**NEW
WILLOW SPRINGS
MIDDLE SCHOOL**
Lovejoy Independent School District

Request for Information 068

Lovejoy ISD - Willow Springs Middle School
1101 W. Lucas
Lucas, TX 75002

Subject: Plumbing Relocation at Boys ADA Shower

RFI 68

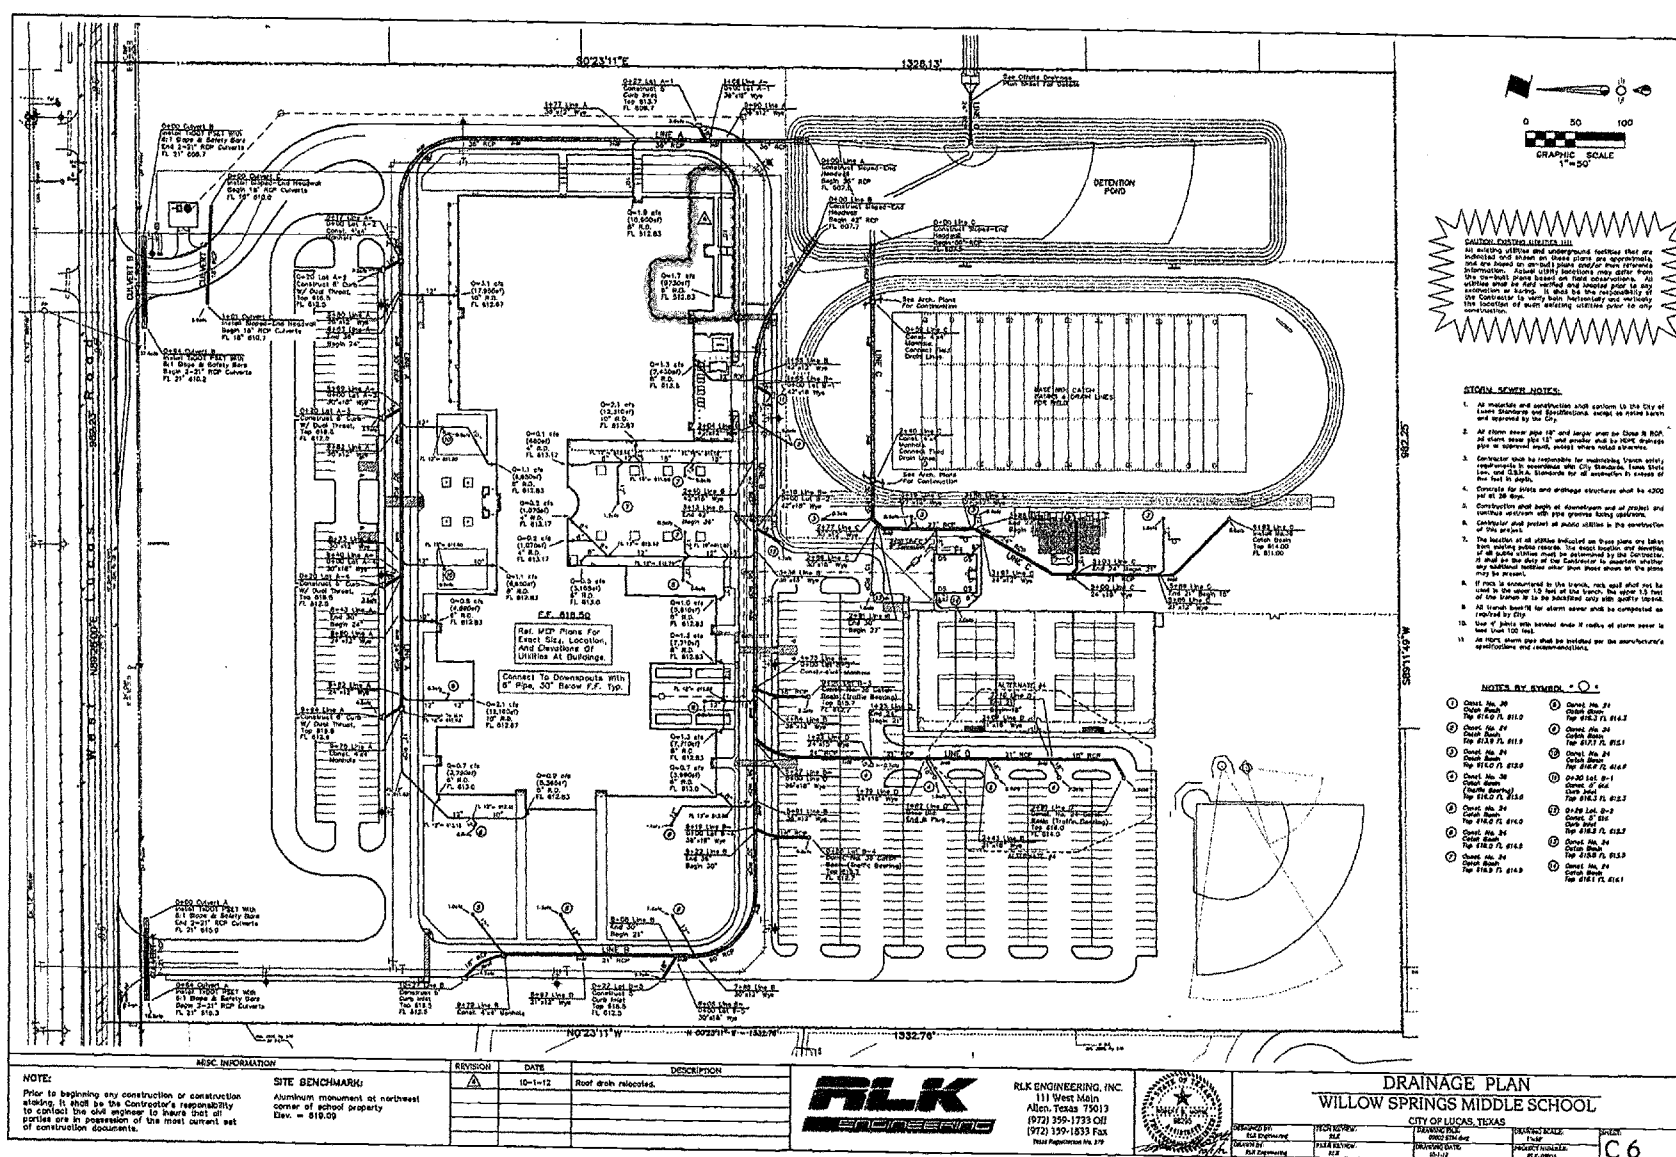
Please see attached.

The 10" HDPE storm sewer line that connects the roof drain (as shown on the original set of plans) to Storm Line A needs to be extended 100' to the new roof drain location. See attached. A portion of the 10" HDPE already installed may need to be relaid in order to achieve a minimum of 0.6% slope in the additional 100' of 10" line. If you have any questions, please let me know.

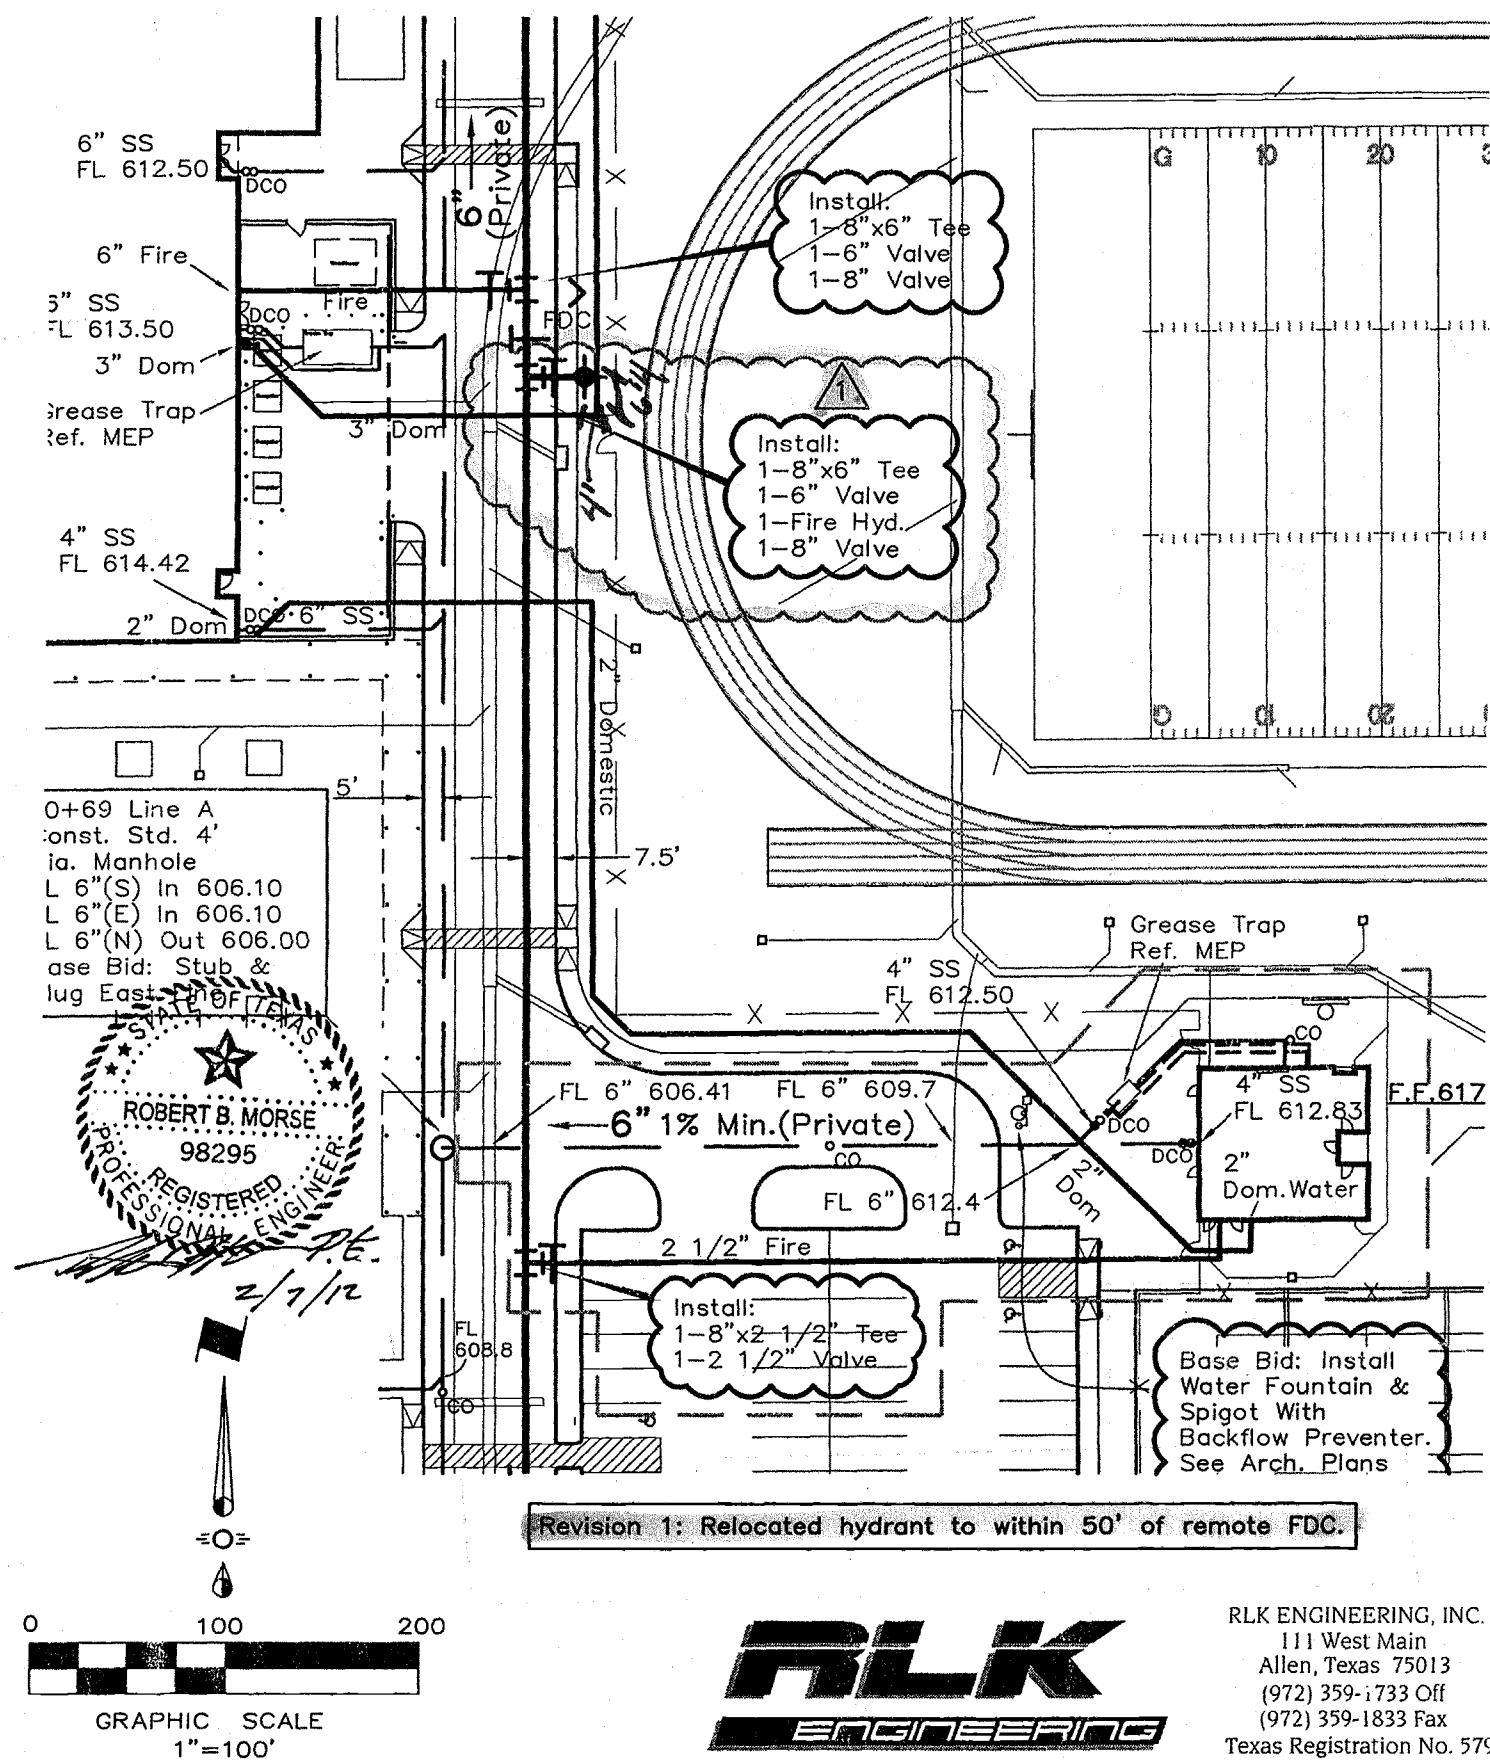
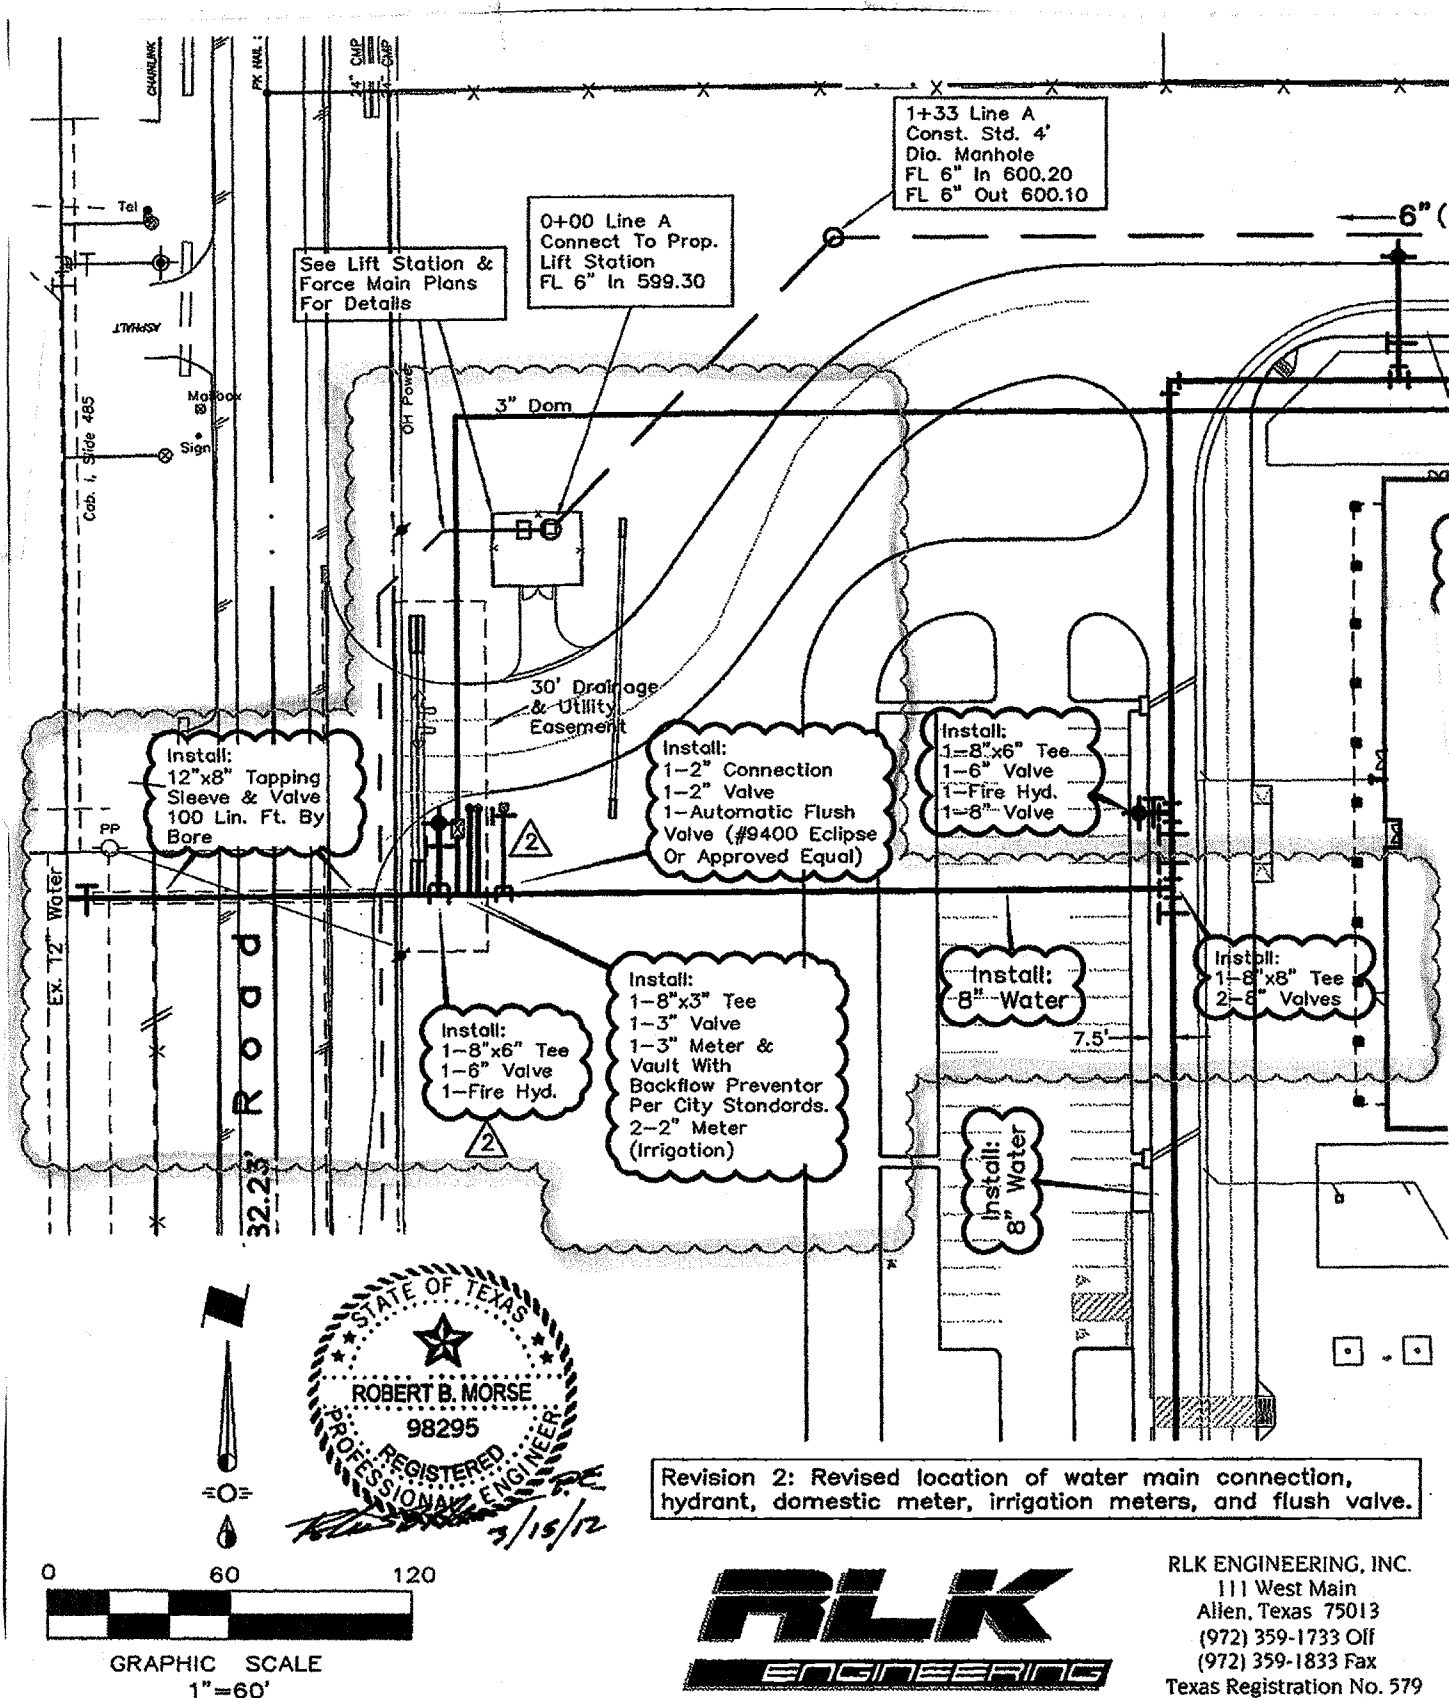
- Delete fire sprinkler system and appurtenances from outdoor concessions building as shown on attached sketches SKP-01 and SKP-02.
